ST. TAMMANY PARISH

Addendum No.: 1

Bid#: 26-16-2

Project Name: Rosedown Way Drainage – Phase 2

PROJECT NO. 11813
SHEET NO. 2B

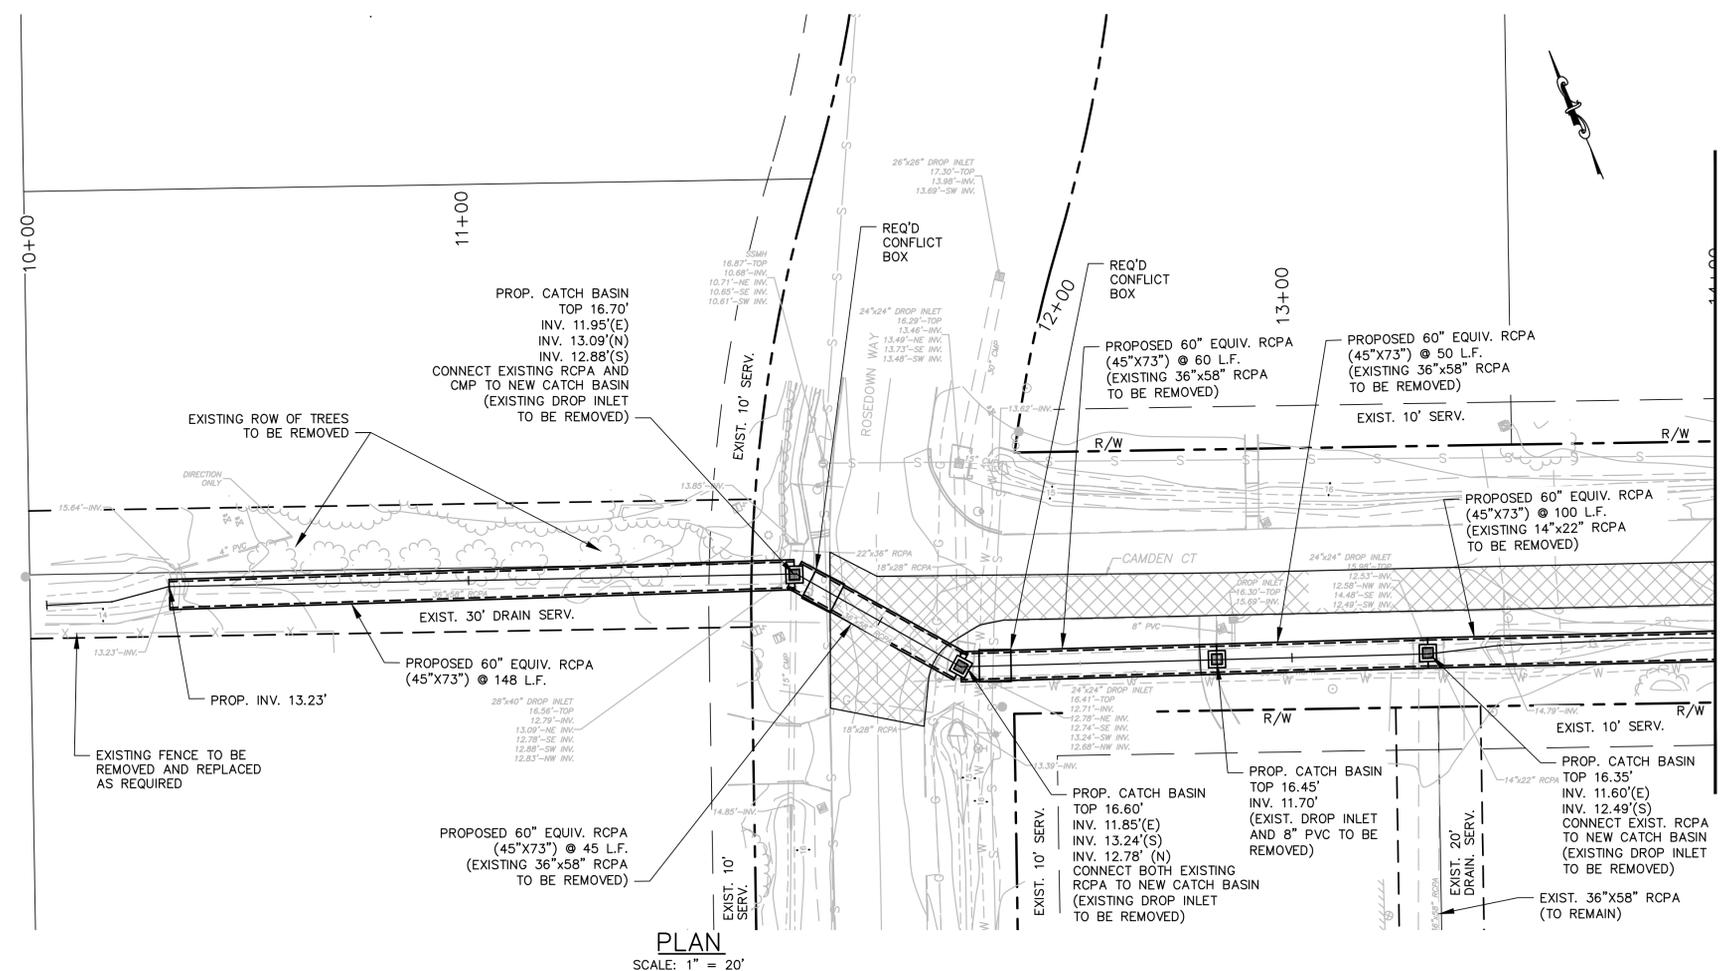
Question 9. If the item Type 610 Limestone Base (8" Thick) is for under the concrete pavement item. How are we to be paid for the areas around the headwalls where we need to put 610 limestone?

Question 16. You give the quantity of the rip rap but don't provide a thickness. Can you provide a thickness so we can quantify the quantity of rip rap needed?

Answer 9. This specific area around the proposed headwalls has been revised to Rip Rap. Bid Item has been updated accordingly.

Answer 16. This has been revised accordingly in this addendum.

PROJECT NO. 11813
 SHEET NO. 3

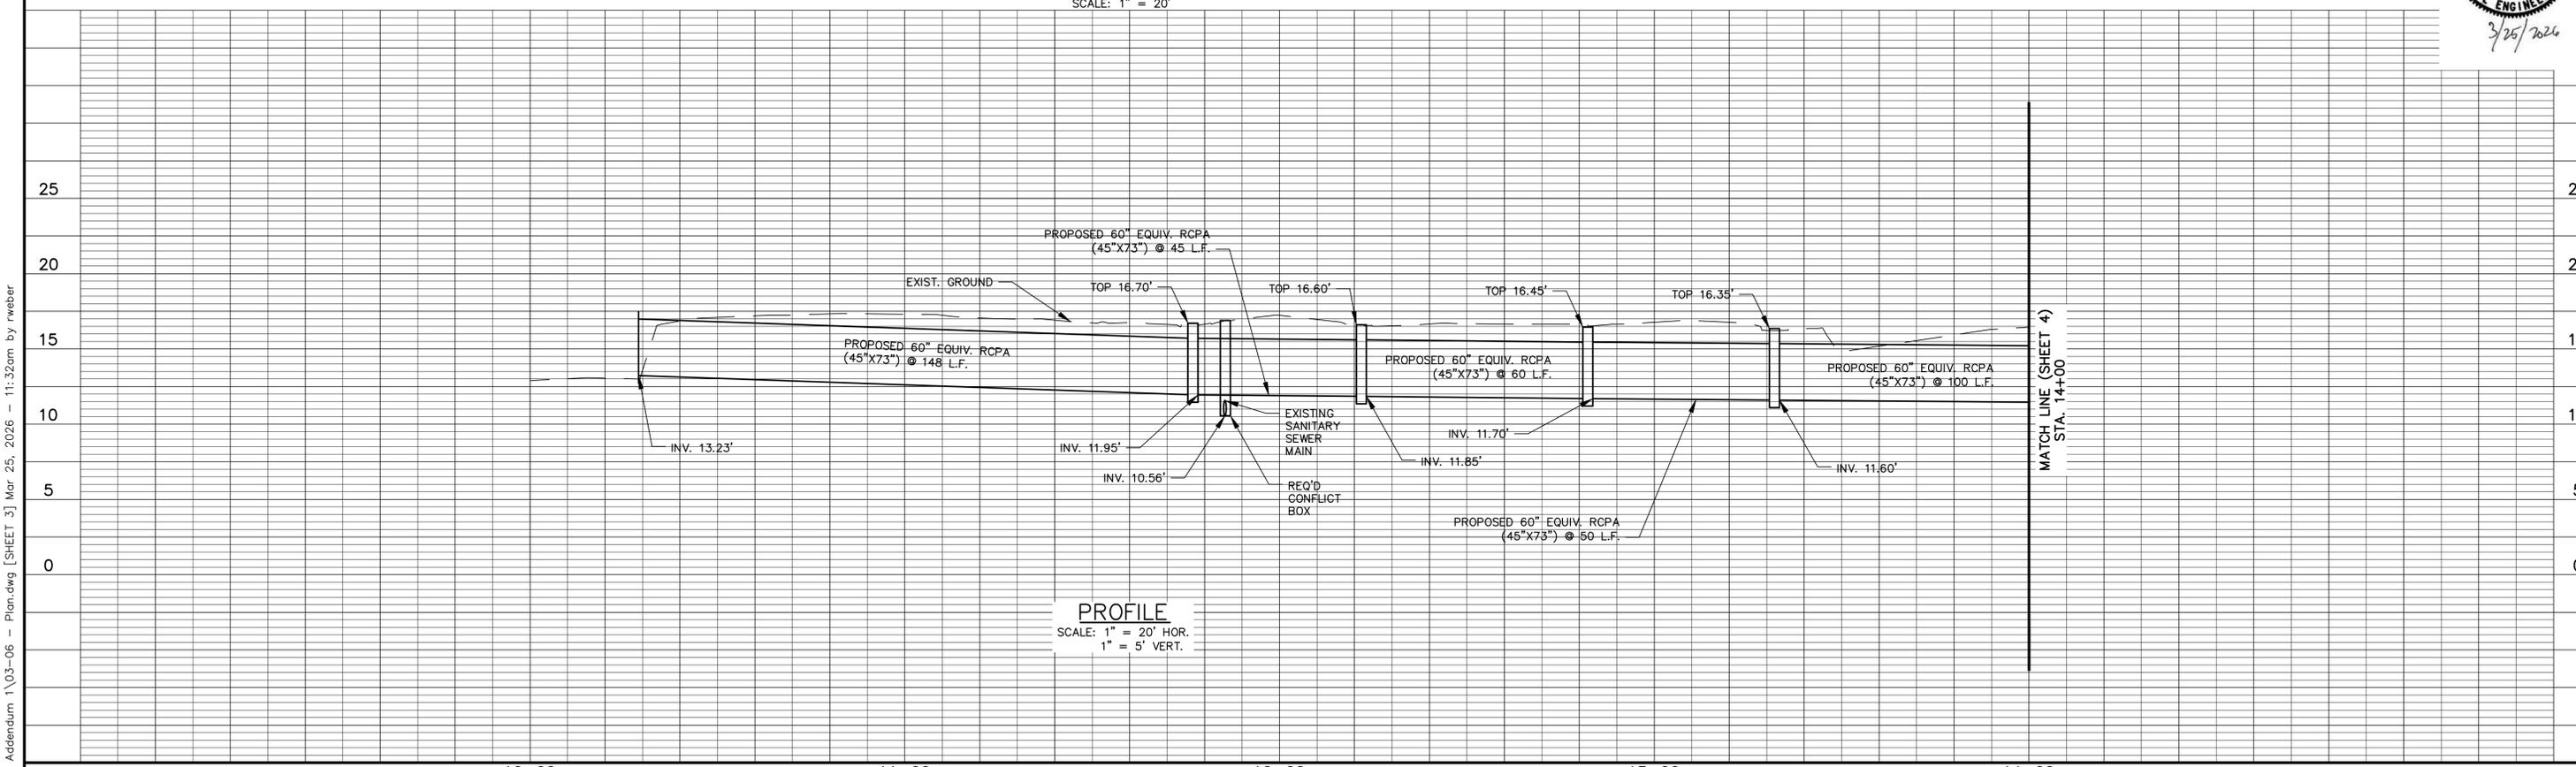
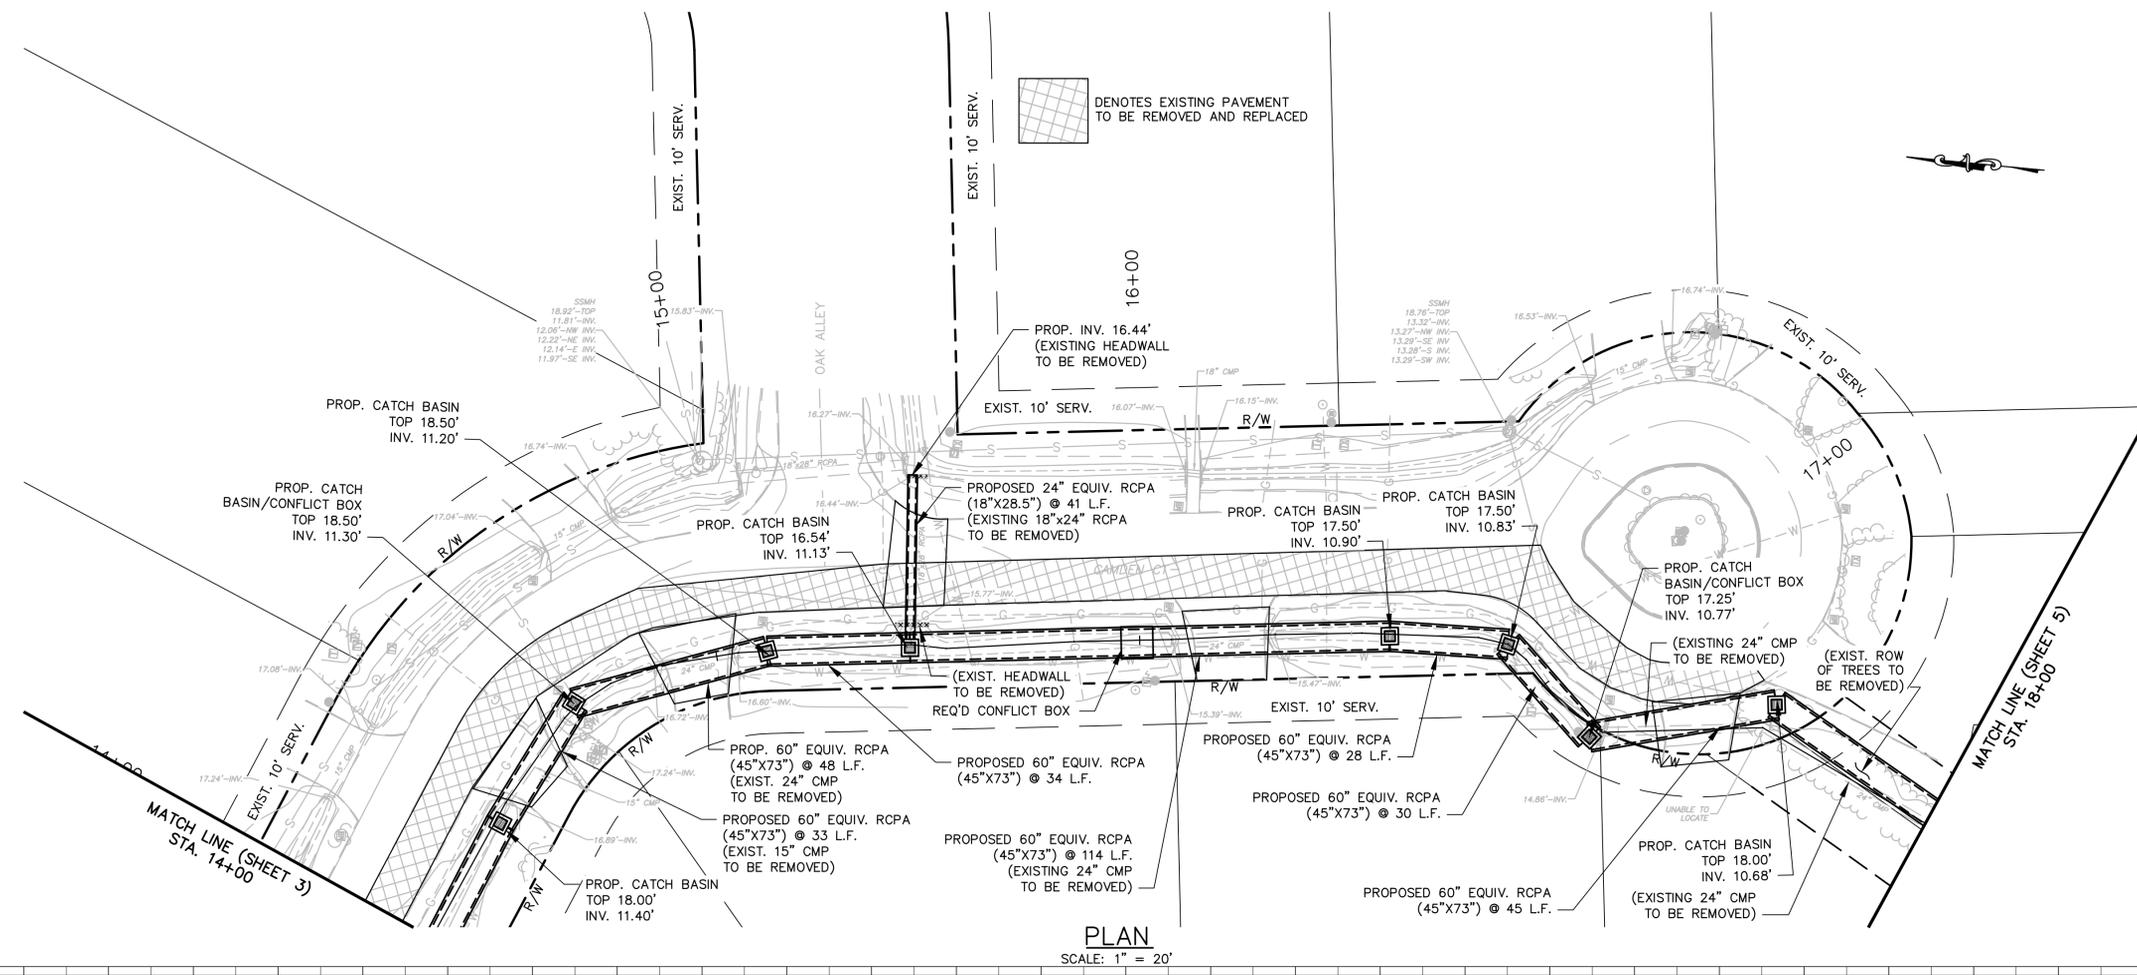
Question 1. On sheet 3 are we to remove the 8 trees that run north of the 60” RCPA 148 LF run? If so, do those trees need to be replaced or replanted?

Answer 1. Yes, trees in this area are to be removed.

PROJECT NO. 11813
SHEET NO. 4

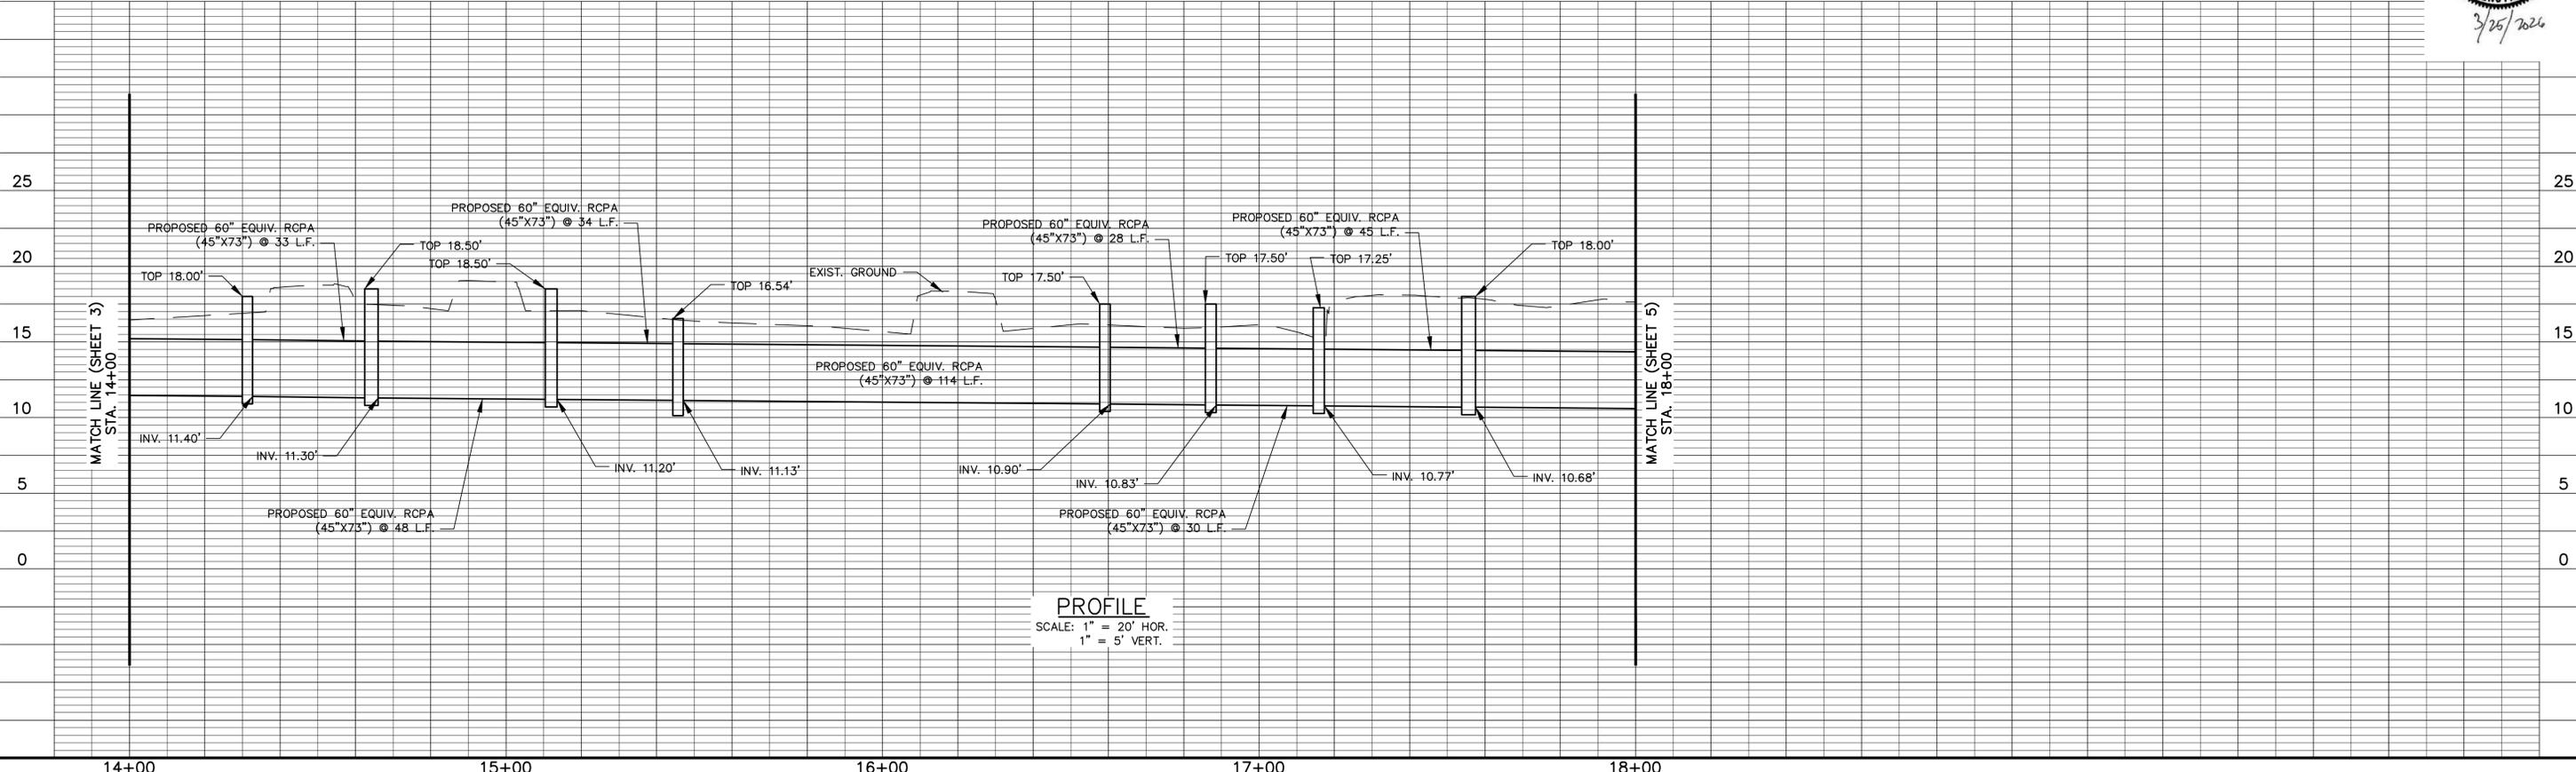
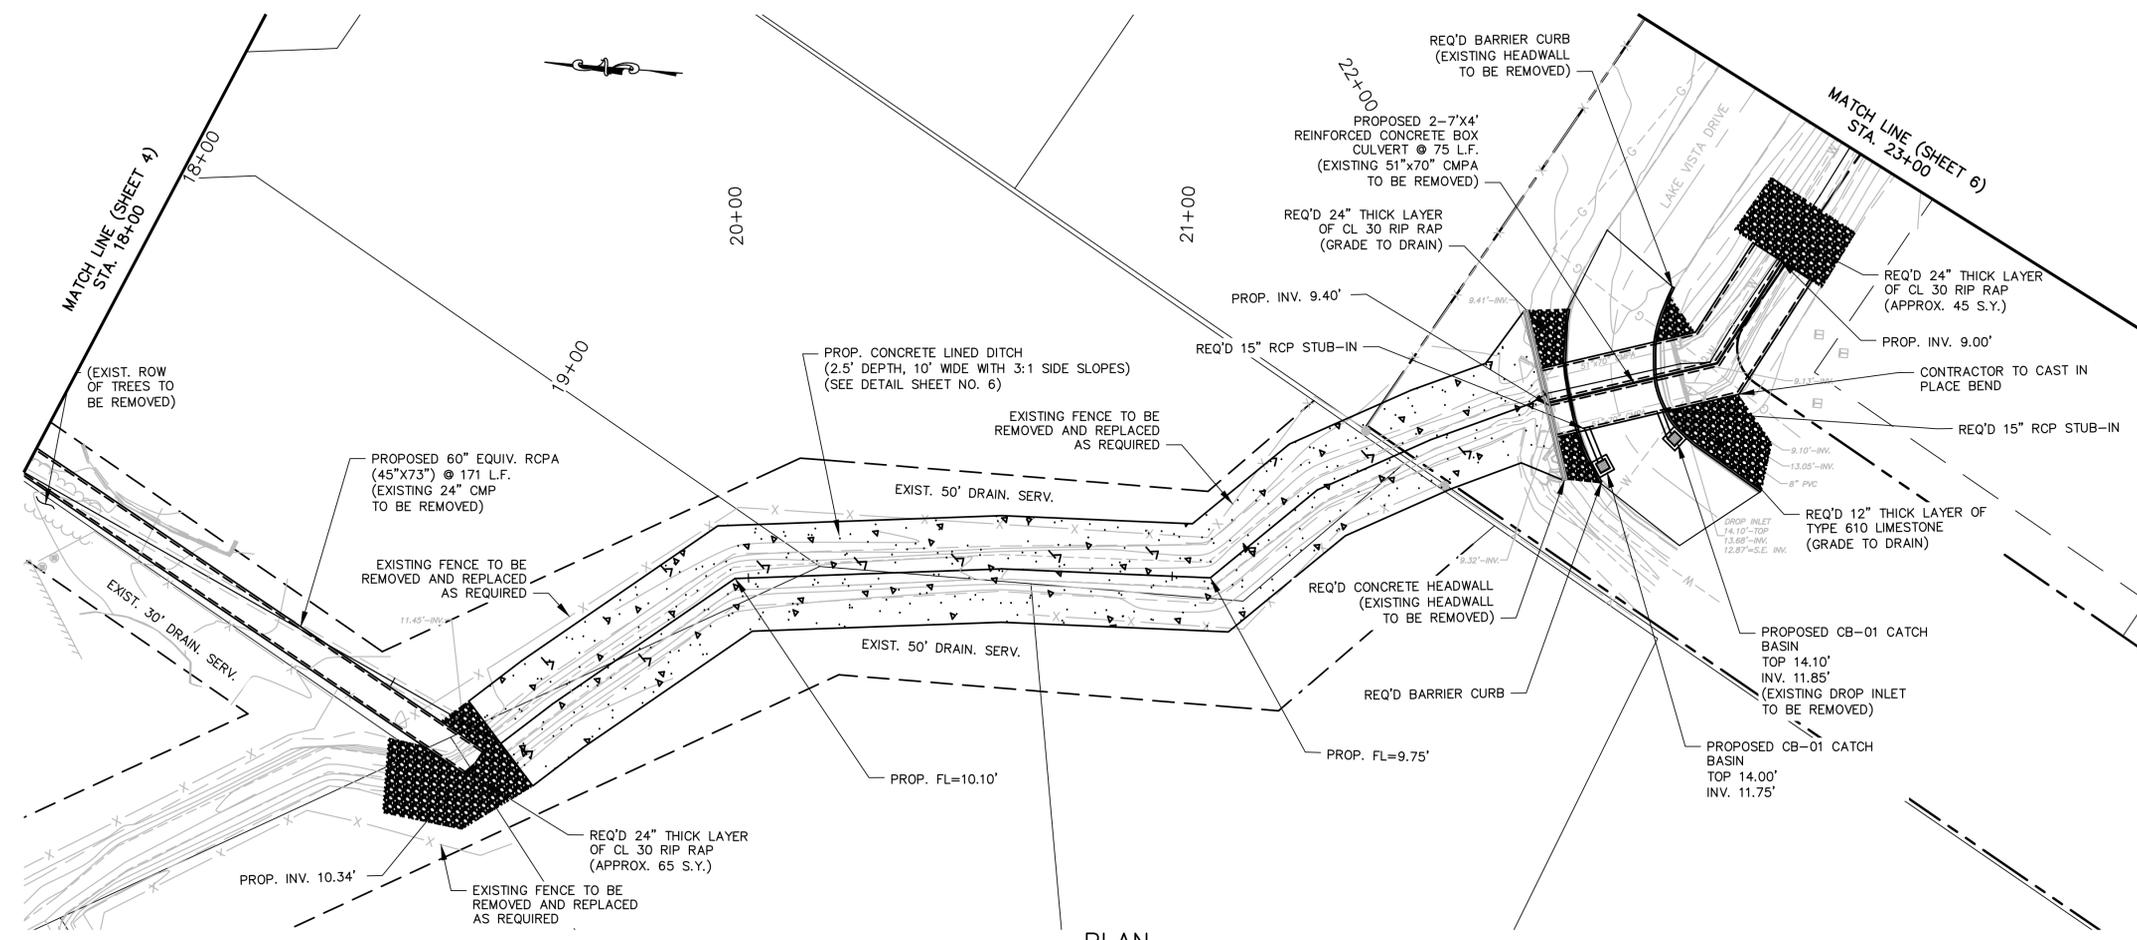
Question 8. On sheet 4 they show a fire hydrant right in the path of new drainage are we to move that? If so, what item would it be paid under? Or will it be moved prior due to the note "Existing water mains and services to be relocated by others and is not included in this contract"?

Answer 8. Utilities will be relocated by others as necessary and are not part of this contract.
